Longer life for sprayer and infeed mechanisms

New Cam for Alternative Sprayer

Value: Maintenance Equipment: HD, Atlantic Catalogue code: VRB003

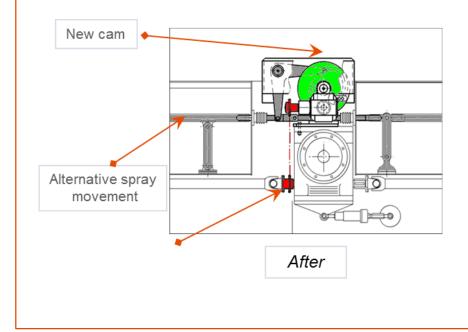
- The new cam moves sprayers in both directions
- Reduced inertial effect on the mechanism
- Reduced load on infeed/outfeed units (driving the sprayers system)
- Smoother movement of sprayers

- New driving system with cam for alternative sprayers
- A new cam is installed on the reducer
- Alternative sprayer movement is controlled by universal joints
- No need for springs
